FIELD SERVICE BULLETIN

FSB Number: LVCCFSB2004-249
Author: Ross Karlen
Date: December 10, 2004
Total No. of Pages: 5
Subject: **3G V980 – No / Intermittent CLI Display**
Model Affected: 3G V980's
Level of Repair: 3

Step 1: CLI board as assembled (For Disassembly of Flip, view Level 2 Service Manual posted on the WEB)

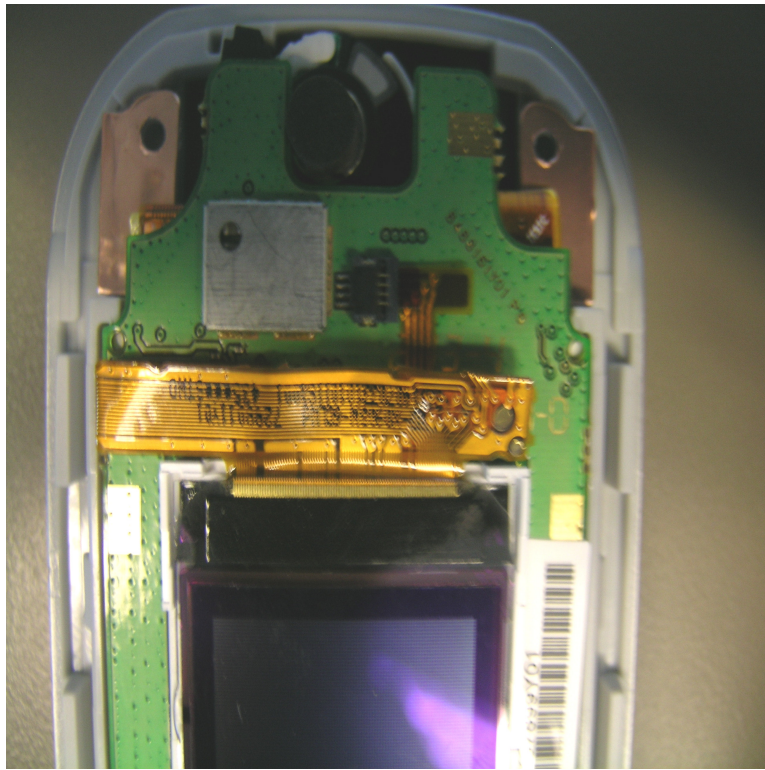
Service is aware of an issue, highlighted by Development. Some units were returned with a customer complaint of “No CLI Display or Intermittent CLI Display” during OOB inspection. Analysis revealed the CLI Flex component shorting to the PCBA copper etched date code to cause CLI failures.

Short Term Solution: Follow the following procedure of adding Kapton Tape on the PCBA.

Use Kapton tape as insulator
Dimension of tape: approx 19 mm x 5.5 mm
Location: over the current P/N (see slide 5)
Color of tape: Optional
